# Memorandum

To: Salt Lake City Historic Landmark Commission  
From: Aaron Barlow, Principal Planner, [aaron.barlow@slcgov.com](mailto:aaron.barlow@slcgov.com) or 801-535-6182  
Date: June 1, 2023  
Re: PLNHLC2022-00675 – Trolley North Student Housing Development

This memorandum provides updated information on the proposed Trolley North Student Housing Development New Construction Petition PLNHLC2023-00675. The referenced application was discussed at the Historic Landmark Commission Meeting on January 5, 2023. At that meeting, the commission tabled the request citing shortcomings in the submitted materials and failure to comply with a number of standards. Their feedback was articulated in a letter sent to the applicant (dated January 17, 2023, included in [Attachment I](#)) and was based upon the standards of review for New Construction in a Historic District ([21A.34.020.H](#)) and the Design Guidelines for Historic Apartment and Multifamily Buildings found in [Chapter 12](#): New Construction.

# Comparison of Previous and Revised Submittals

# 700 S STREETSCAPE

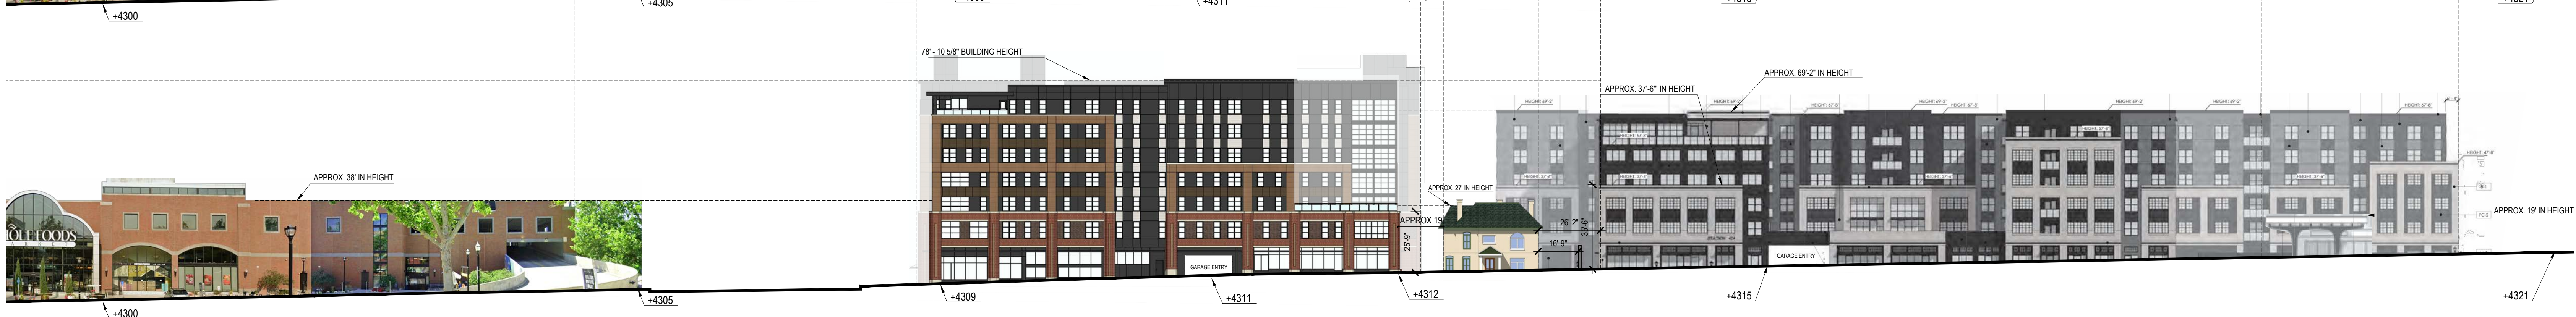
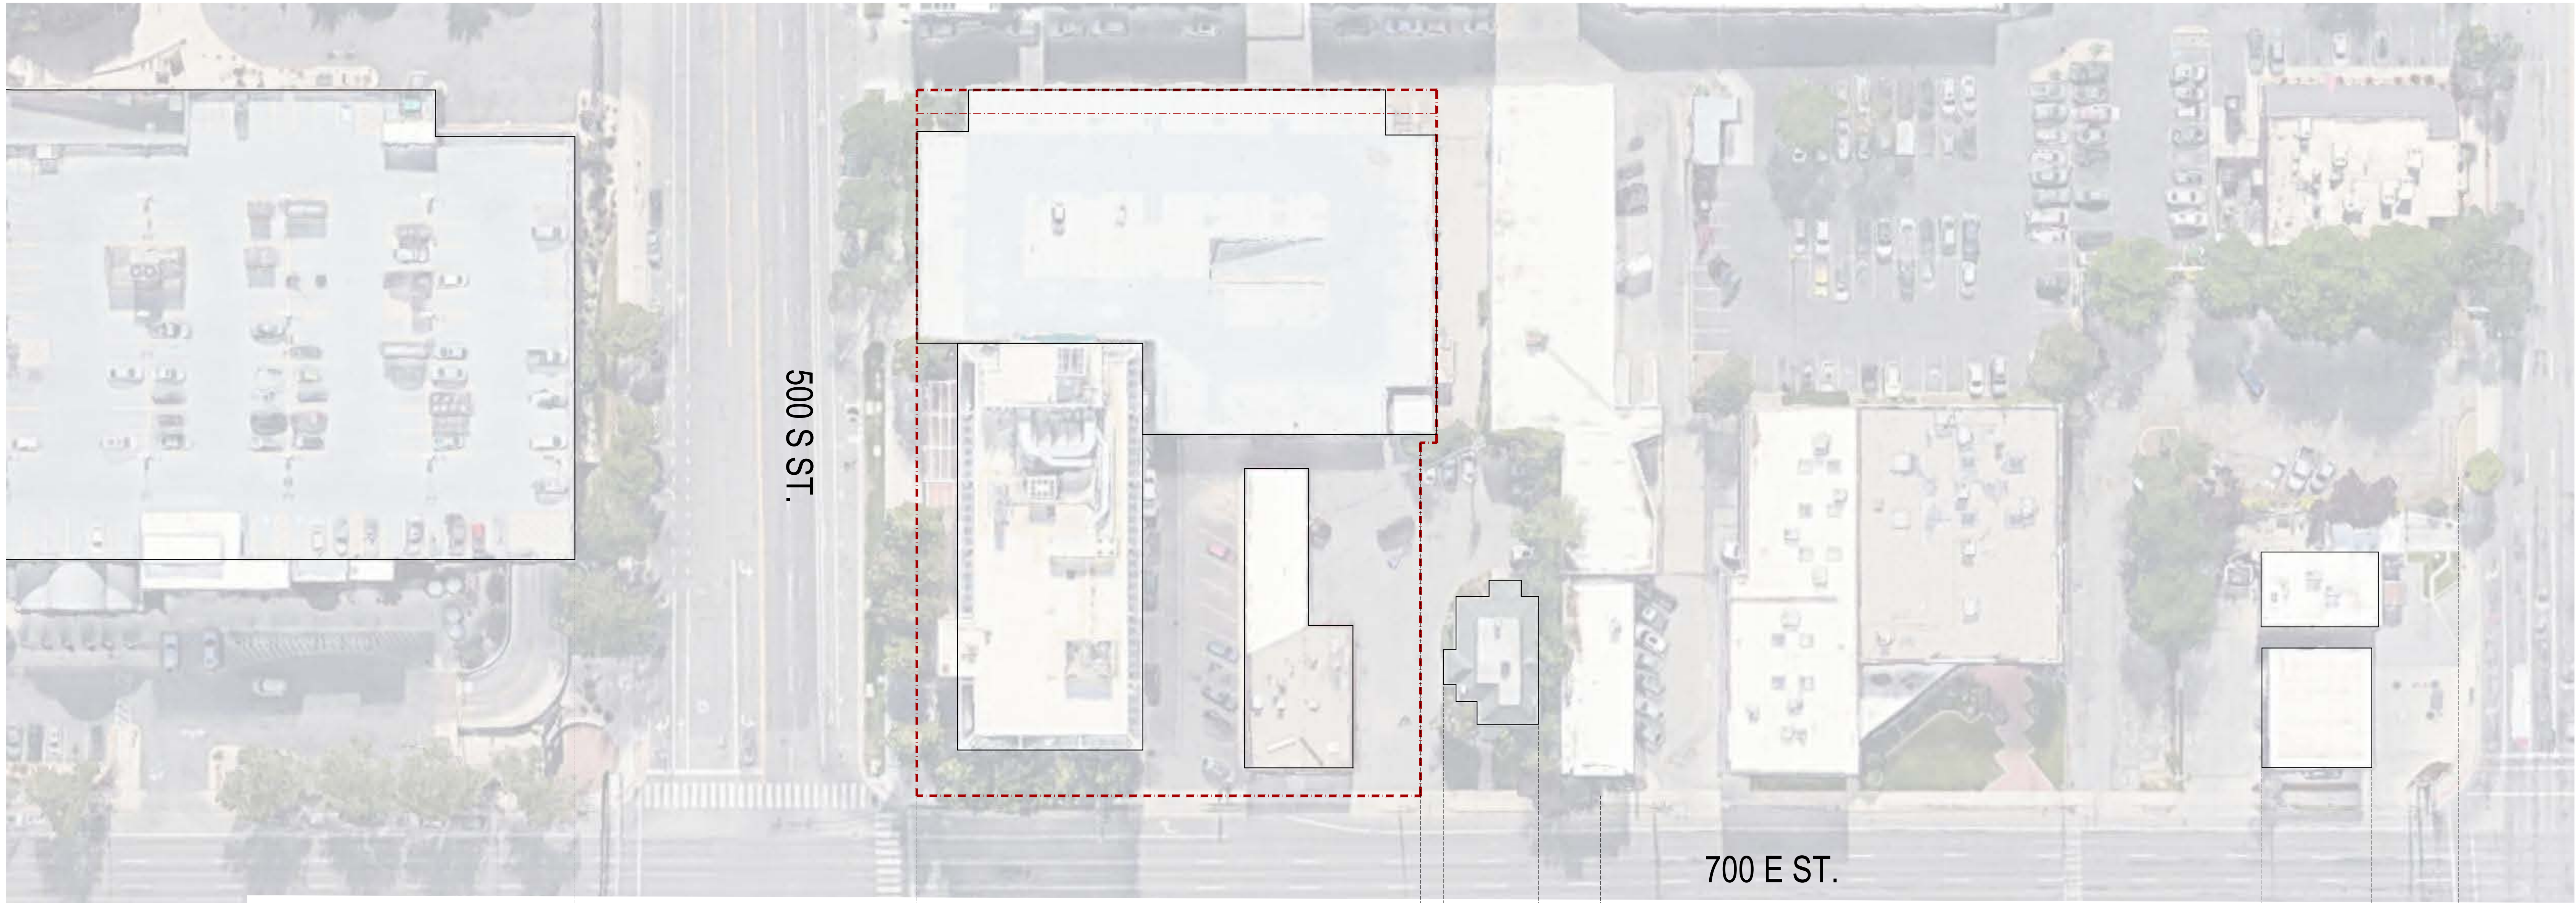
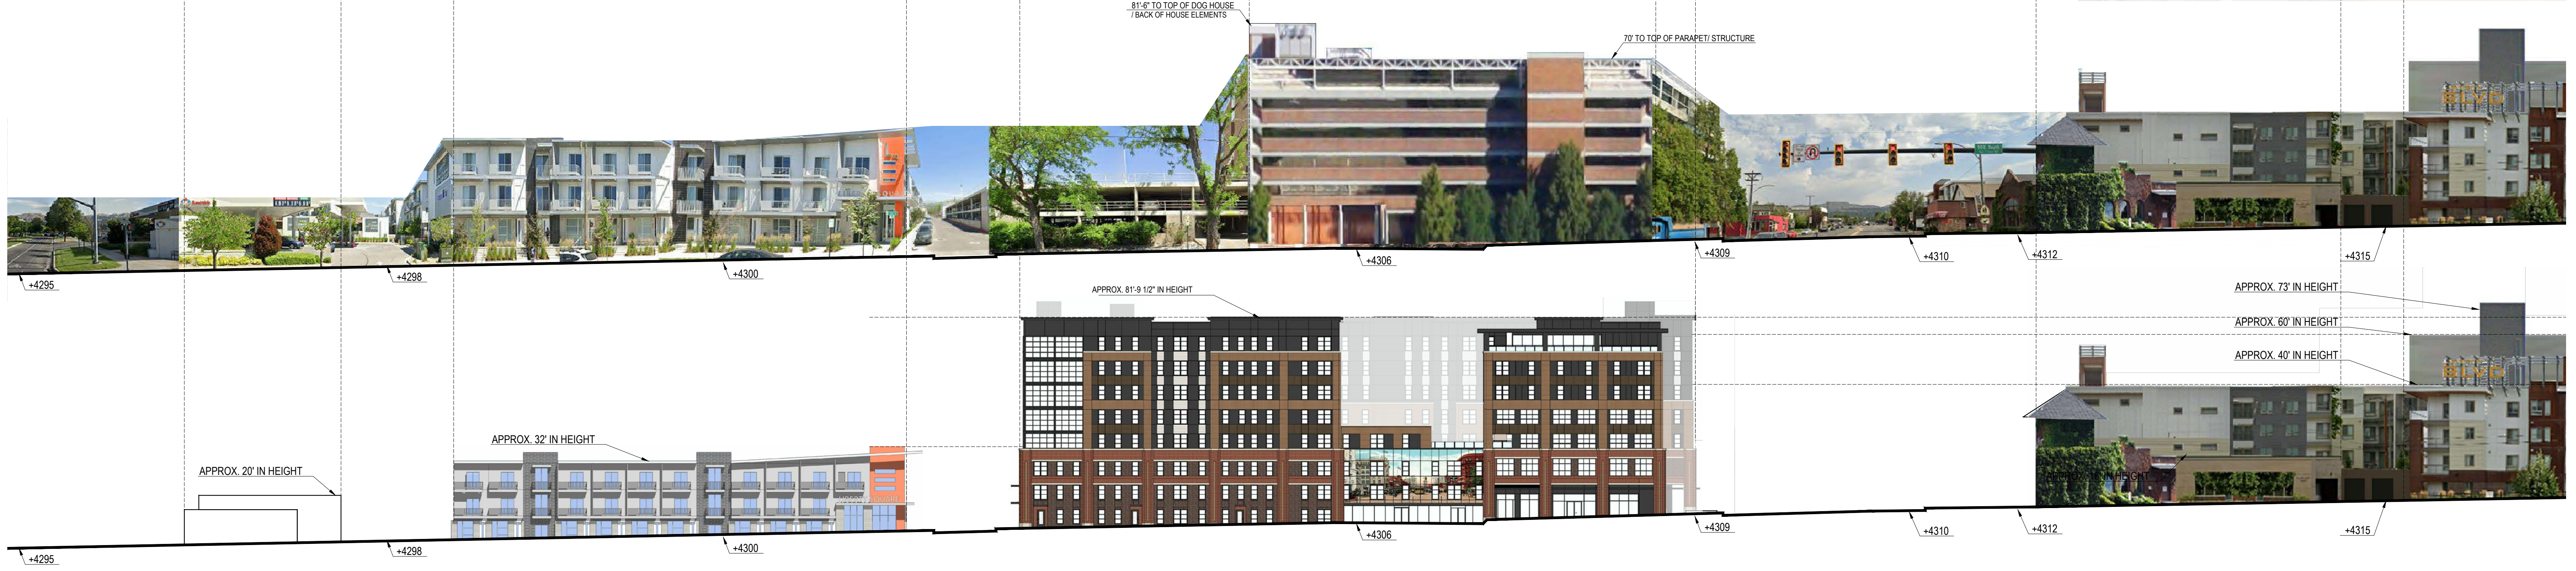
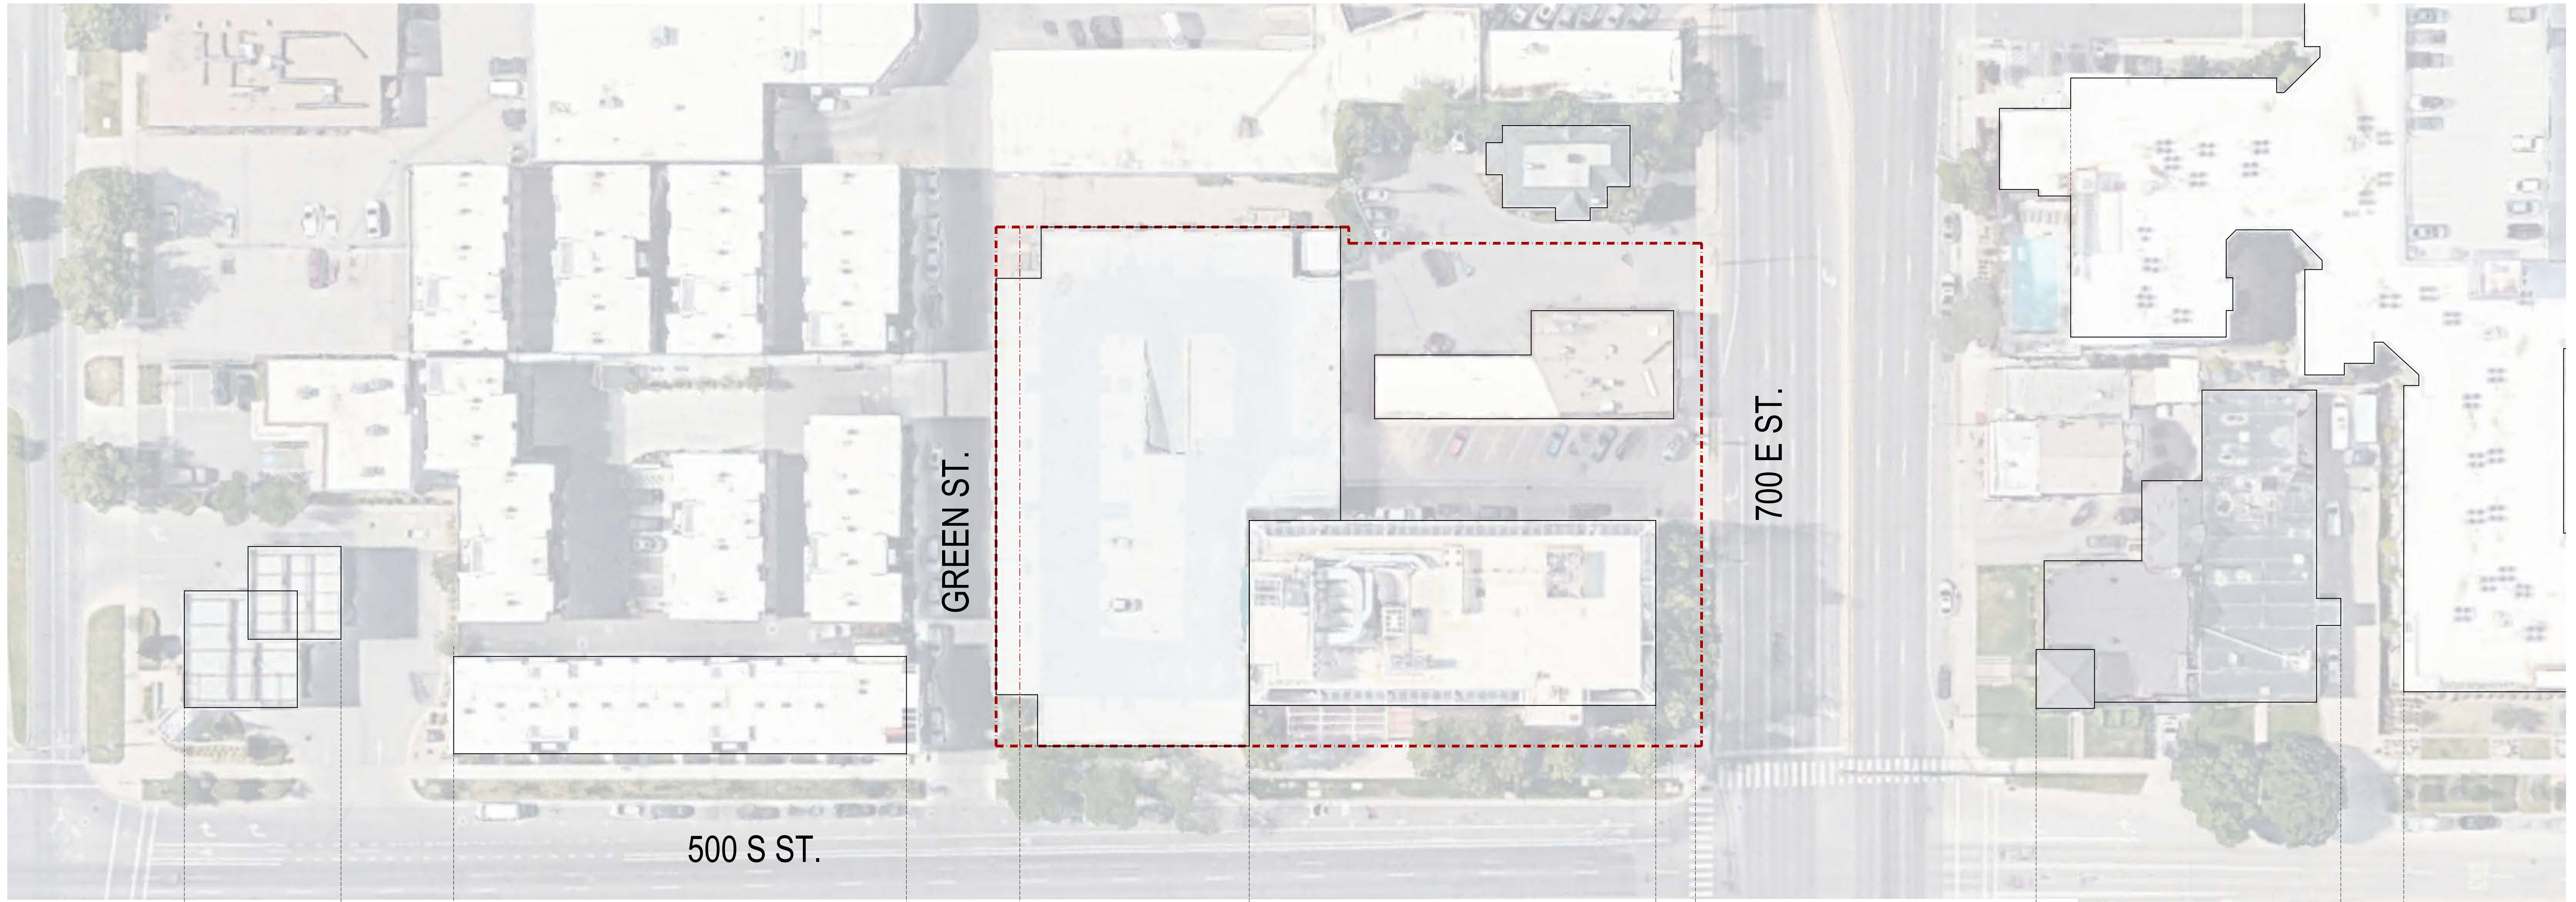
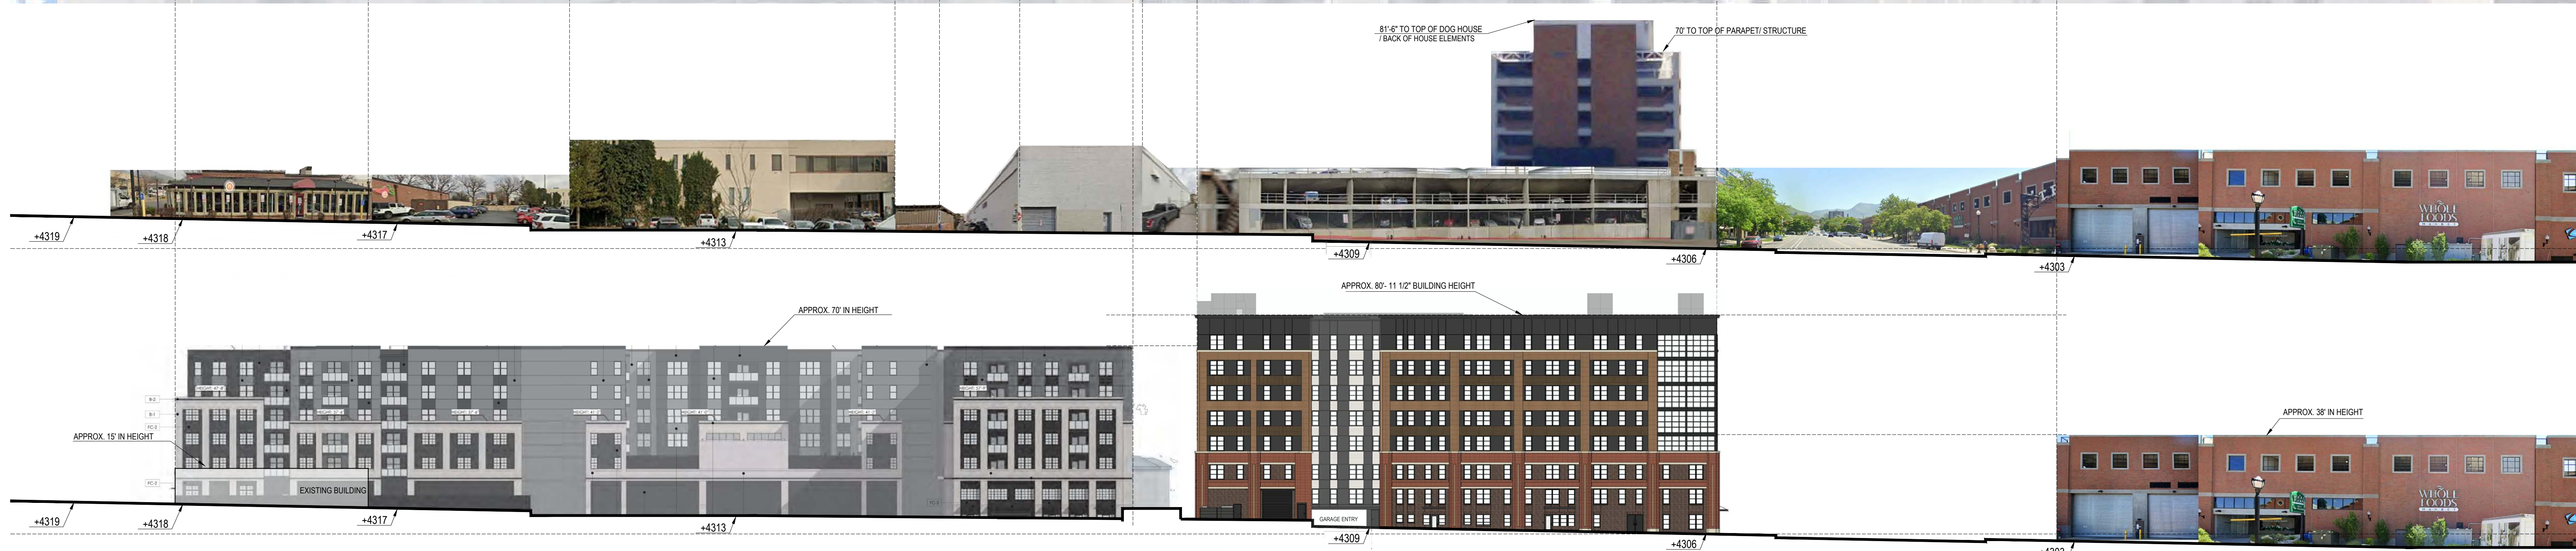
<b>Scale and Design</b>		
<p>The proposed building appears to be much larger than the surrounding development. Please show how it will fit into the neighborhood in your streetscape study.</p> <ul style="list-style-type: none"> <li>• New Construction Standards 1c, 1d, 4a, &amp; 5a</li> <li>• Design Guidelines 12.6, 12.7, 12.8, 12.9, 12.10, 12.42, 12.45, 12.46, 12.50, 12.53, 12.54, &amp; 12.57</li> </ul>	<p>The streetscape studies included with the revised proposal illustrate how the design of the proposed building acknowledges and relates to adjacent development by drawing lines between masses of the design with nearby buildings. In staff's view, the updated proposal has much more carefully considered adjacent buildings with the proposed mass and design.</p>	<b>Complies</b>
<p>The proposal fails to acknowledge the discrepancy in scale between the new building and the existing Mulloy (Hancock) Mansion. Due to its proximity, you will need to reduce the new building's impact on the adjacent buildings. While this can be addressed through any number of changes to the proposal, additional setbacks and stepbacks should be seriously considered. Please consider buffering the proposal from the adjacent property. This should also include additional treatment to the North façade to soften the scale of the blank wall.</p> <ul style="list-style-type: none"> <li>• New Construction Standards 1c, 1d, 4a, &amp; 5a</li> <li>• Design Guidelines 12.6, 12.7, 12.8, 12.9, 12.10, 12.42, 12.45, 12.46, 12.50, 12.53, 12.54, 12.55, &amp; 12.59</li> </ul>	<p>Revisions to the proposal illustrate several strategies that have been implemented to acknowledge the discrepancy in size between the proposed building and the Mulloy (Hancock) Mansion. Specifically, the applicant has implemented the following:</p> <ul style="list-style-type: none"> <li>• Increasing the setback from the north property line from zero feet to ~9 feet</li> <li>• Stepping back the front ~15 feet of the upper floors from 700 East at the northeast corner of the building</li> <li>• Climbing vines along the section of the north wall that is adjacent to the Mulloy Mansion property.</li> <li>• A landscape buffer between the structure and the property line</li> <li>• Additional fenestration and glazing on every floor of the east portion of the north façade.</li> </ul> <p>All these modifications have enabled the proposal's design to mitigate visual impacts on the historic mansion and other adjacent buildings (including Liberty Square).</p>	<b>Complies</b>

The streetscape studies included with the revised proposal illustrate how the design of the proposed building acknowledges and relates to adjacent development by drawing lines between masses of the design with nearby buildings. In staff's view, the updated proposal has much more carefully considered adjacent buildings with the proposed mass and design.
